BARANGAROO SOUTH

Stage 1B Public Domain Modification S4.55

Project
BARANGAROO STAGE 1B
PUBLIC DOMAIN
Modification S4.55

Drawing Title
**HICKSON PARK BOLLARD
STRATEGY**

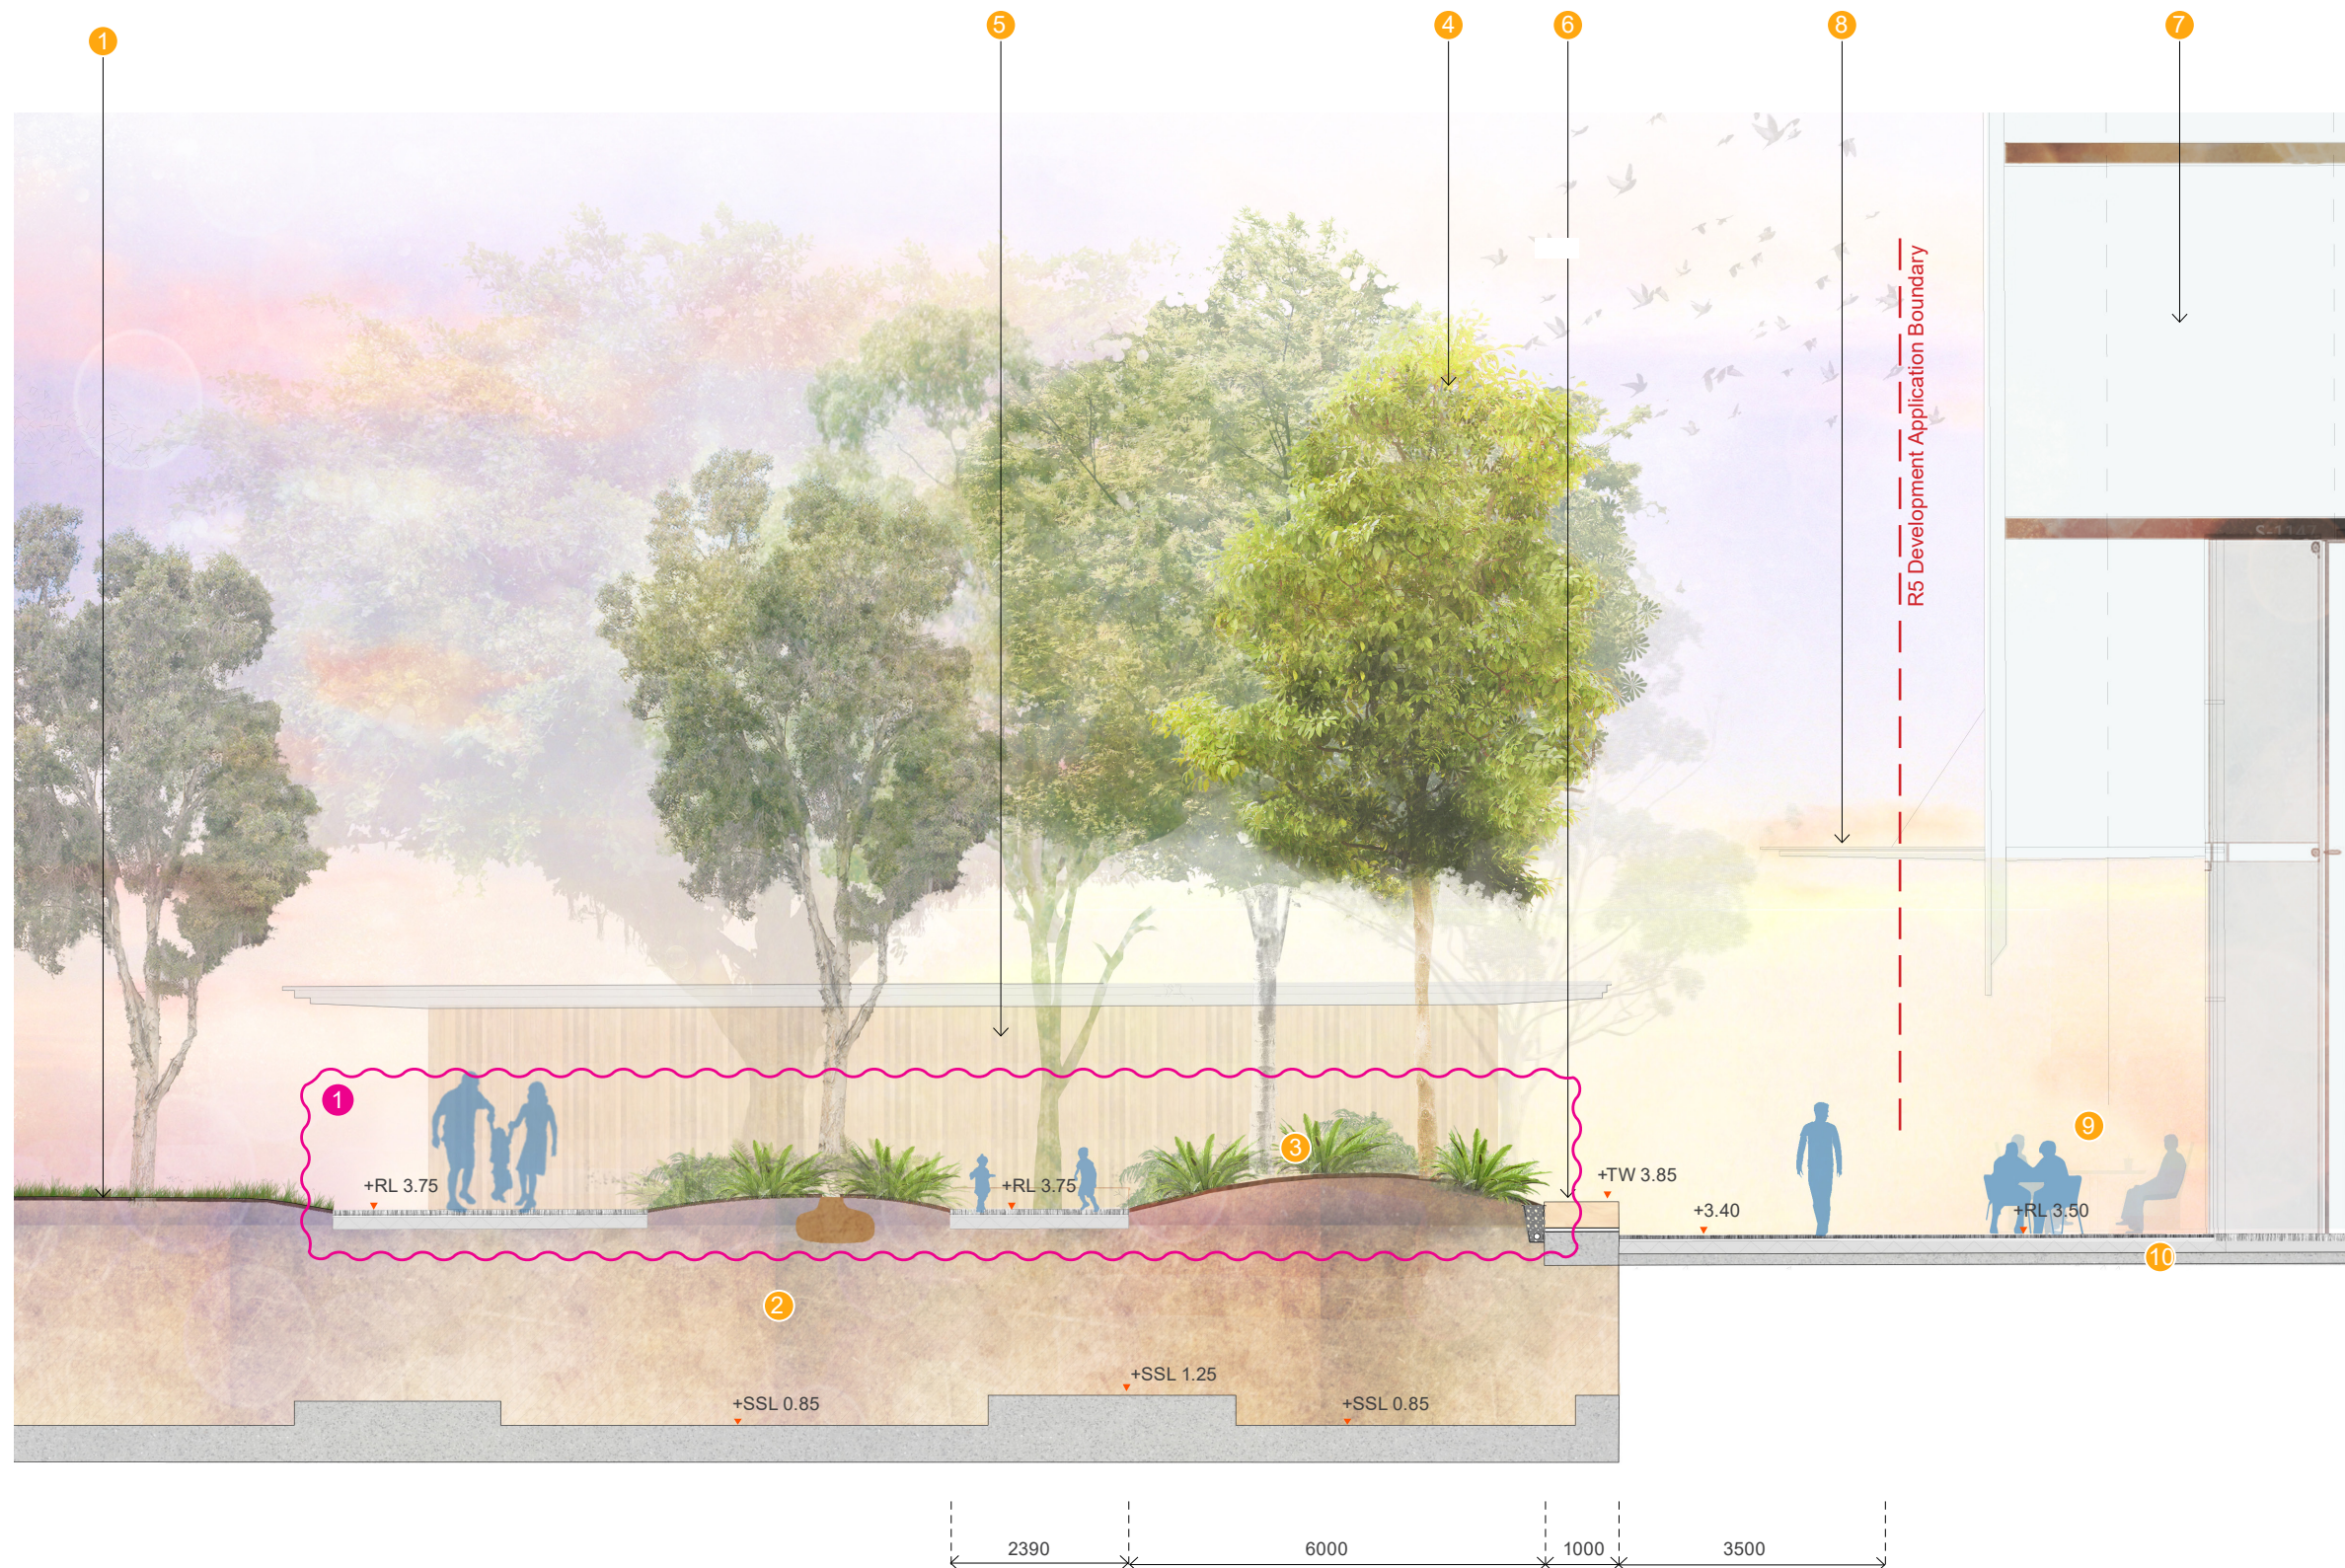
- 1 Sandstone paving strip changed to City of Sydney paving along Hickson Park
- 2 Sandstone bollards changed to concrete & setout amended.
- 3 Additional smart pole

Drawing Title
HICKSON PARK SECTION
J-J
Drawn
SS

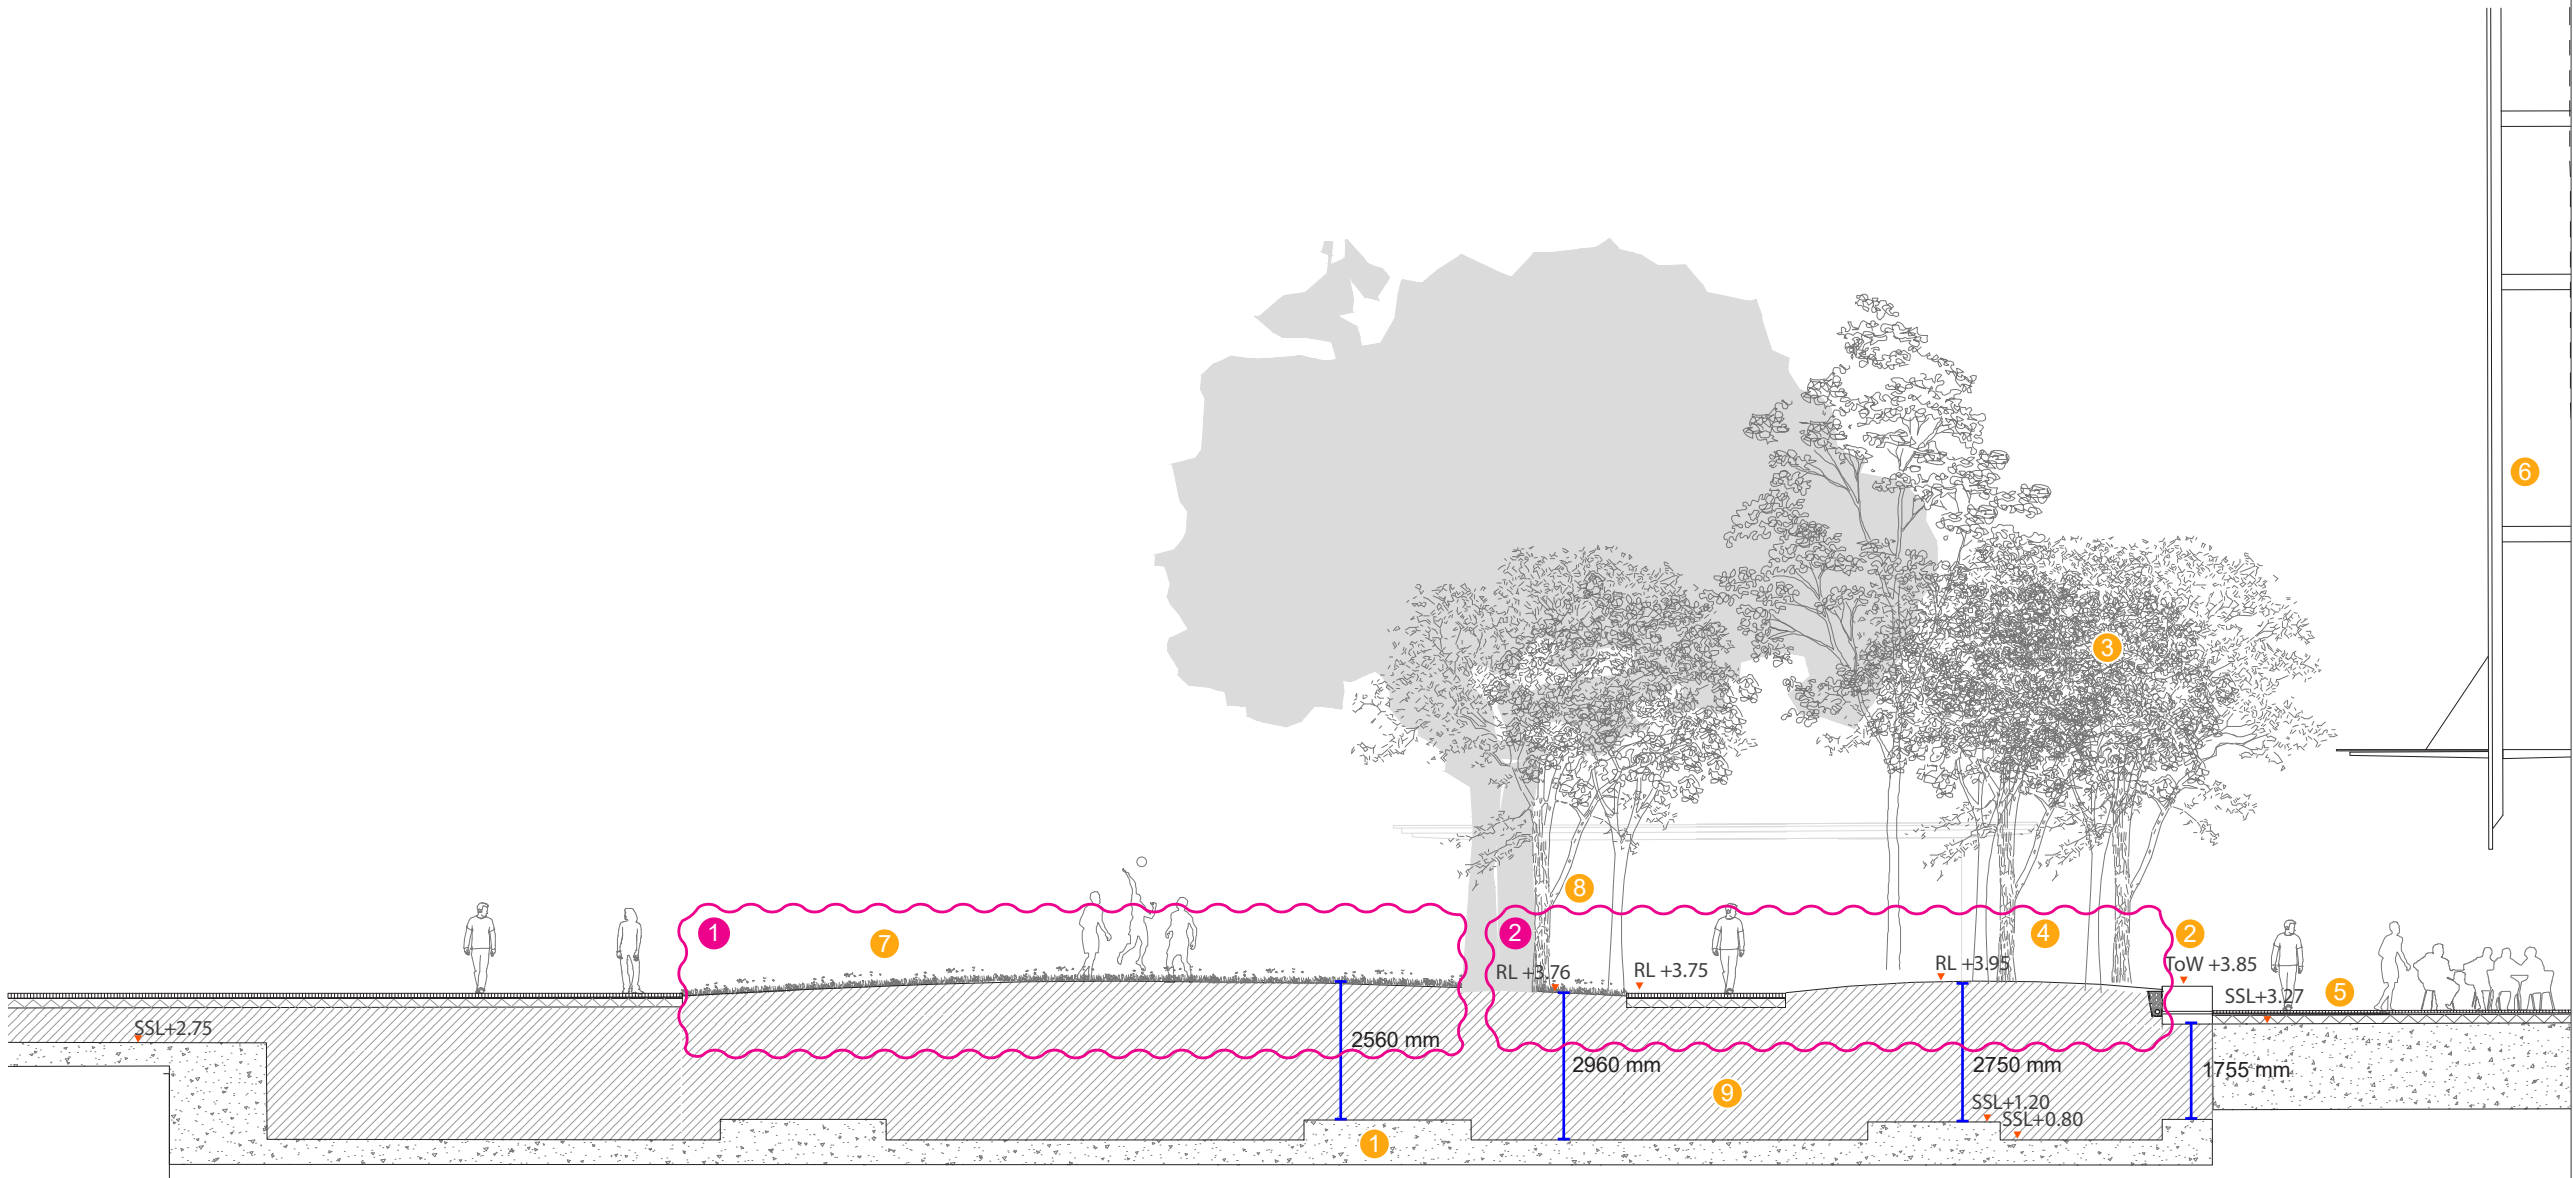
- Proposed Modifications**
- Amendment cloud
 - 1 Levels changed due to proposed Hickson Road levels

Drawing Title
HICKSON PARK SECTION
K-K

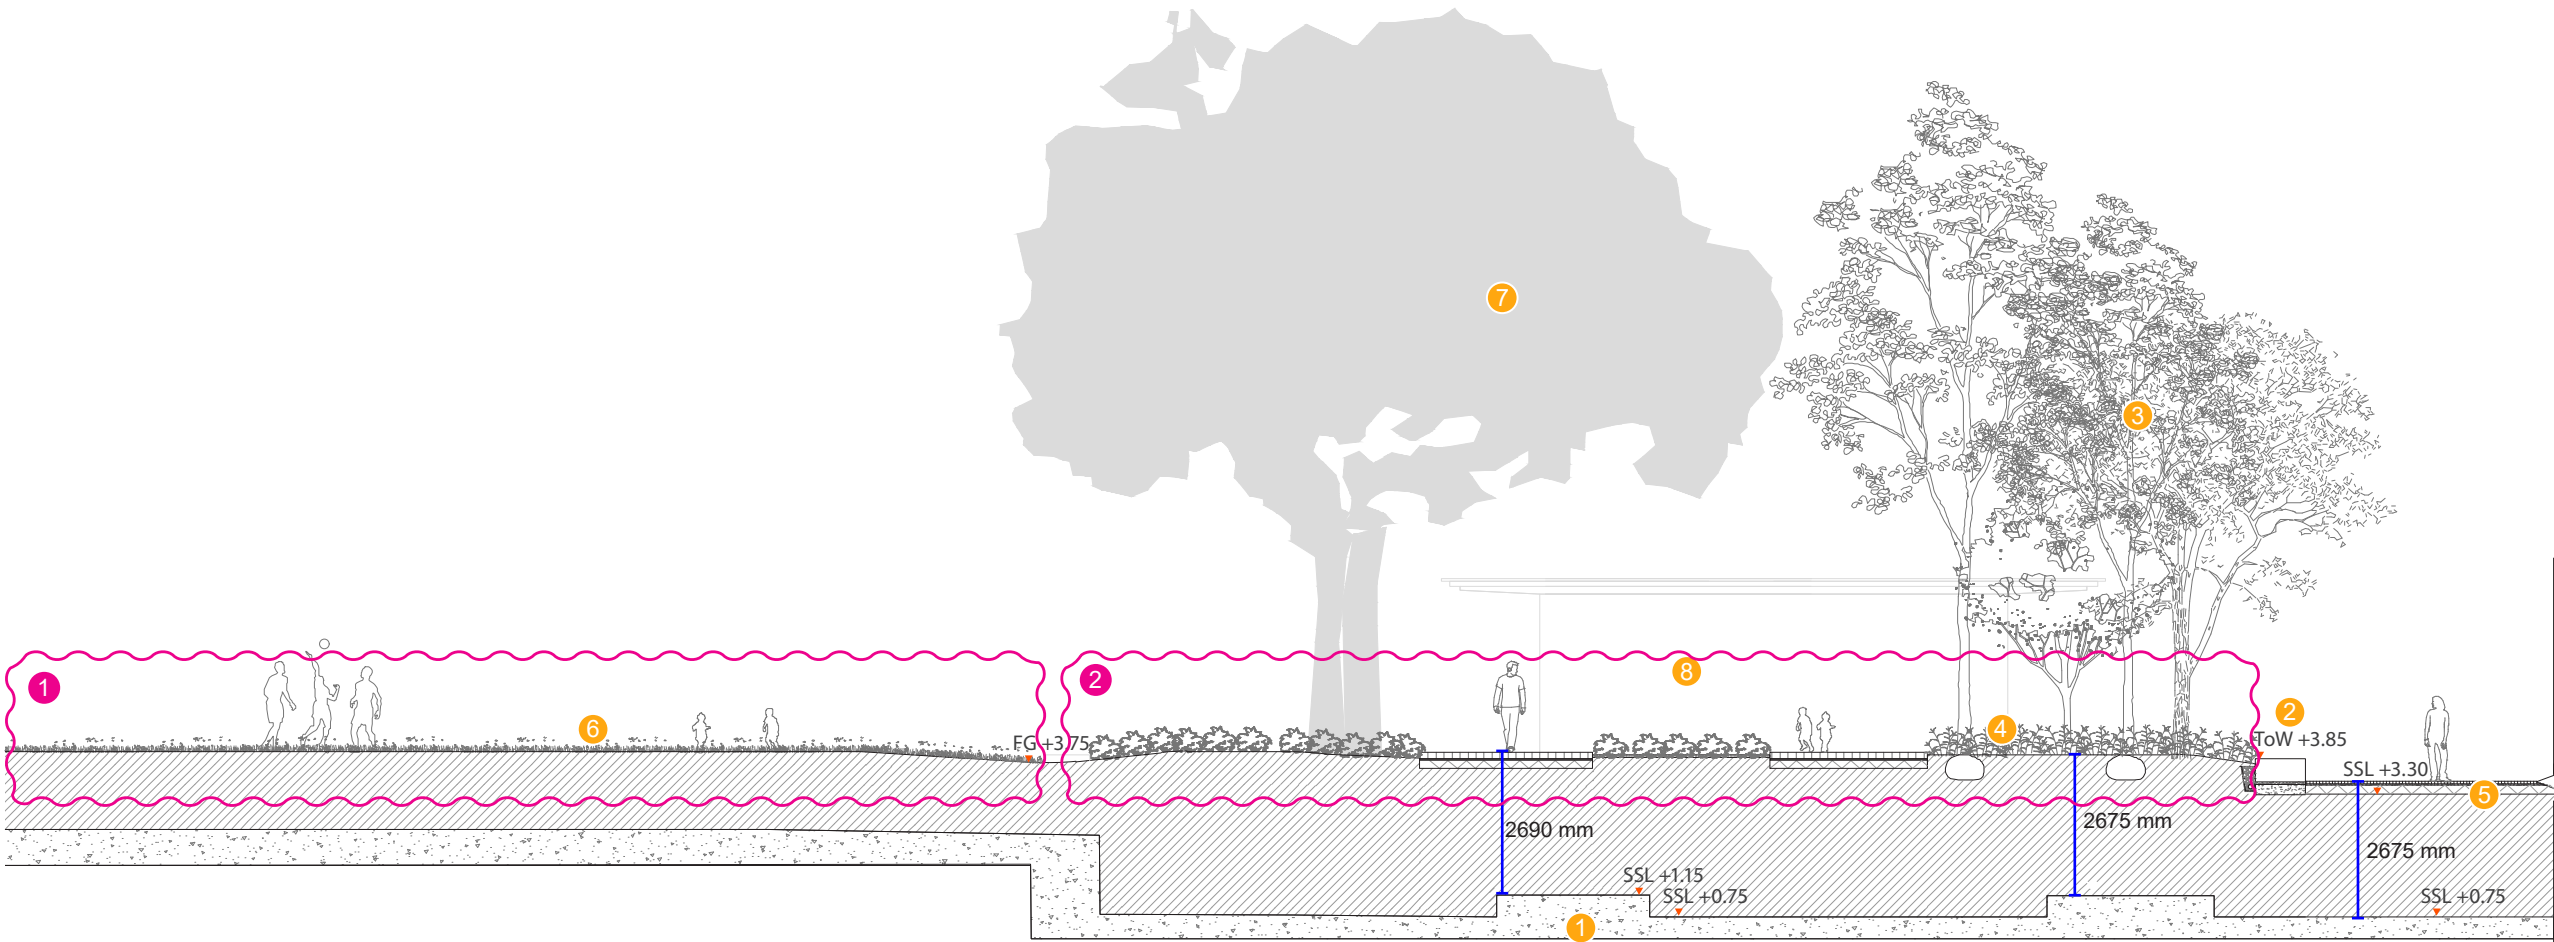
- 1 Levels changed due to proposed Hickson Road levels
- 2 Increase planting area within the park and change of geometry.
